# Strike-Draft 2021 Clean-Up LUCA Attachment B November 30, 2021 20.10.200 Suburban Residential Districts (R-2.5, R-3.5, R-4, R-5). Suburban Residential Districts provide for residential areas of low to moderate densities (2.5, 3.5, 4 and 5 dwellings per acre), and permit compatible, related activities. \*Effective only within the jurisdiction of the East Bellevue Community Councilland Sammamish Commented [A1]: Topic 1. LUC References and Numbering Community Council. Removes outdated reference 20.20.255 Electrical utility facilities. C. Required Review. For new or expanding electrical utility facilities proposed on sensitive sites as described by Figure UT.5-a-7 of the Utilities Element of the Comprehensive Plan, the applicant shall obtain Conditional Use Permit approval under Part 20.30B LUC. For expansions of electrical utility facilities not proposed on sensitive sites as described by Figure UT. 5a7, the applicant shall Commented [A2]: Topic 1. LUC References and Numbering obtain Administrative Conditional Use Permit approval under Part 20.30E LUC. Correcting reference 20.20.900 Tree retention and replacement. E. Retention of Significant Trees in the R-1 Land Use District in the

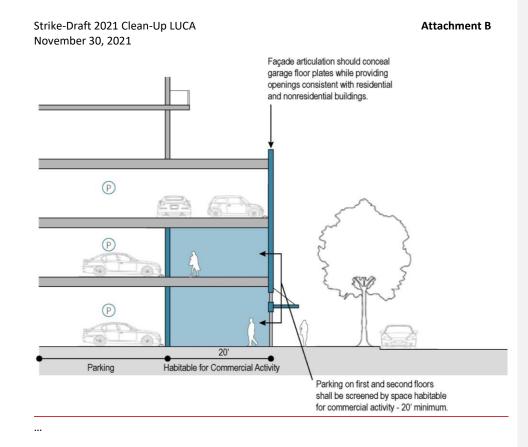
20.25A.170.A.8.b.i that "first and second floors shall be habitable for commercial activity" instead of first only

xiii. Where glazing is required, the applicant may elect to provide a maximum of 25 percent of the openings of the total perimeter wall area of each level as unglazed or the minimum required openings percentage for natural ventilation established by the applicable International Building Code Section 406.5.2, as amended by the Bellevue Building Code, whichever is greater, to ensure the natural ventilation of the garage.
